Design and Access Statement June 9th 2021

Minor Amendments Application

& Discharge of Condition 4h: details of hard landscaping and external steps Design & Access Statement

This Design and Access Statement has been prepared for a series of minor amendments to the permitted development and listed building consent for the existing Grade II listed residential property at 12 Keats Grove, Hampstead, London. The proposal involves fewer changes to the original fabric than originally envisioned, due to the differences in the lifestyle of the new owners of the property contrasted against the highly personal permission granted to the previous owners.

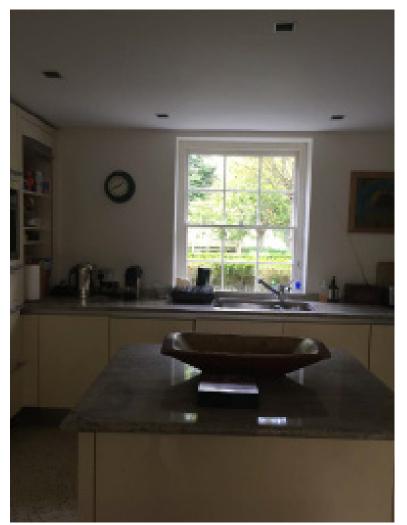
1. Do not reinstate a bedroom on the lower ground floor, a full two stories from the others and isolated from the rest of the family, but rather retain the use of the lower ground floor as purchased, keeping the open plan family living and informal dining and kitchen in the listed building. This approach retains existing service runs and requires no new notching of joists or opening out of existing fabric. See item **A** on attached drawing 8001.
